DEVELOPMENT ASSESSMENT PANEL REPORT				
Application No.	DA/2024/0555			
Address	10 Waterview Street BALMAIN			
Proposal	Partial demolition of existing structures, Torrens title subdivision of the existing lot into two allotments. Alterations and additions to an existing dwelling on lot fronting Waterview Street including construction of a first floor addition and the construction of a new 3 storey detached dwelling house located on the proposed rear lot.			
Date of Lodgement	03 July 2024			
Applicant	Roberto Bianco			
Owner	Paul J Fitzgerald Mrs Suzanne L Fitzgerald			
Number of Submissions	Initial: 13 After Renotification (Amended Plans): 4			
Cost of works	\$1,800,000.00			
Reason for determination at Planning Panel	Number of submissions exceed officer delegation			
Main Issues	Impact to Heritage Conservation Area, bulk and scale and amenity impacts to neighbouring properties, parking and access, loss of tree canopy, and inadequate amenity

Recommendation	Refusal			
Attachment A	Reasons for Refusal			
Attachment B	Draft conditions of consent in the event the application is approved			
Attachment C	Plans of proposed development			
Attachment D	Statement of Heritage Significance of

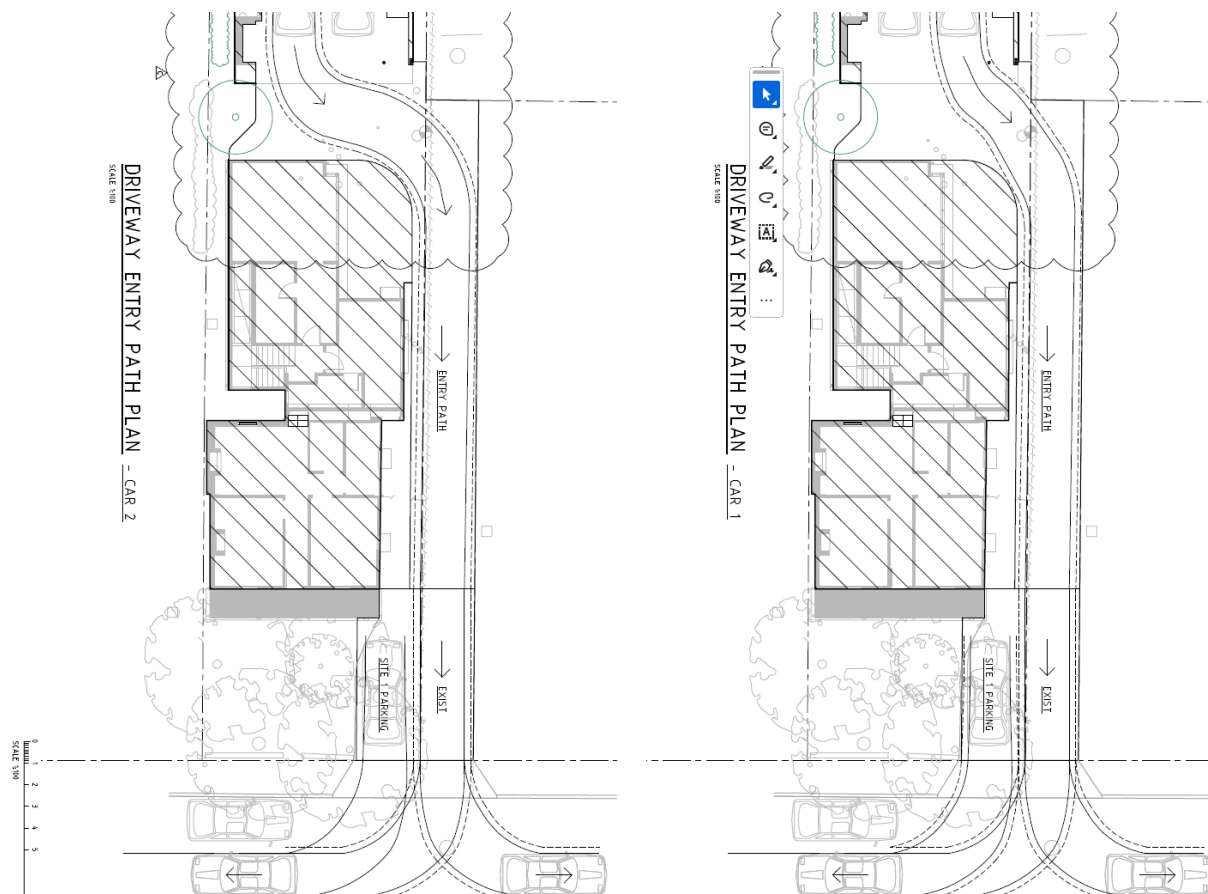
Council’s request for further information letter identified a number of concerns in relation to the proposed car parking as follows:

- The proposed new parking to the rear of the site is not supported both on heritage grounds and on planning grounds where it creates adverse amenity impacts to the private open space of site 1 (the main dwelling), reduces the landscaping within the front of the site to accommodate a new hardstand parking space in conjunction with

- the driveway and it is strongly recommended that it is removed from the proposal.
- If the proposed new parking at the rear of the site is removed, the retention of the existing hardstand space adjoining the boundary at the front would be acceptable.
- However, if the proposed new parking space at the rear is pursued, one of these off-street car parking spaces at the rear should be allocated to the main dwelling and the parking located within the front setback should be removed from the proposal.

The proposal under assessment has not been amended in accordance with the request above and remains fundamentally the same as the original design in this regard.

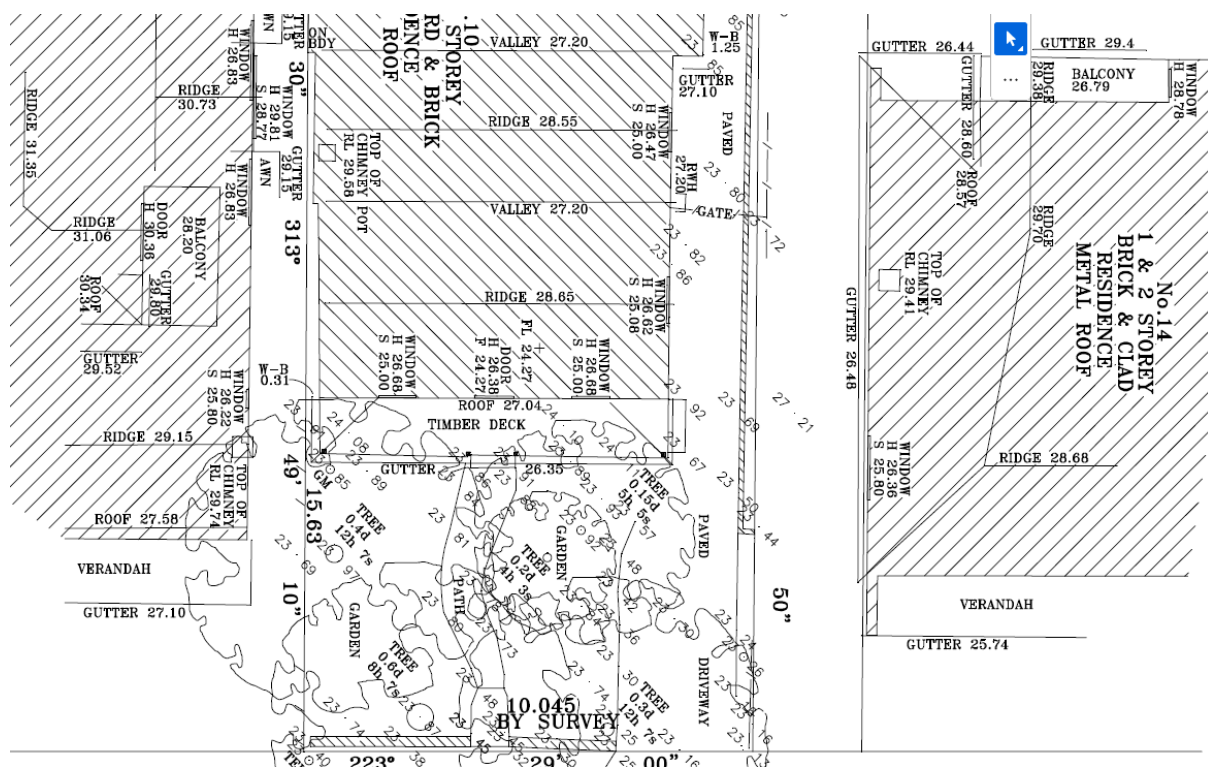
Swept path diagrams, dated 28-11-2024 prepared by Maroubra Consulting Pty Ltd were provided for assessment. And the swept paths indicate that manoeuvring would require the use of the entire width of the driveway on 12 Waterview Street (see extract of the swept path diagram below):

Upon review of this additional information, Council’s Engineers raised concern with regard to a potential risk to the building structure at 14 Waterview Street where its eaves and gutters overhangs/encroach onto the subject driveway (see extract of the site survey below):

As the swept diagrams do not take account of the eaves and guttering that encroach onto the driveway that this proposal is seeking to utilise, it is considered that the proposal has not demonstrated that it complies with AS/NZS 2890.1:2004.
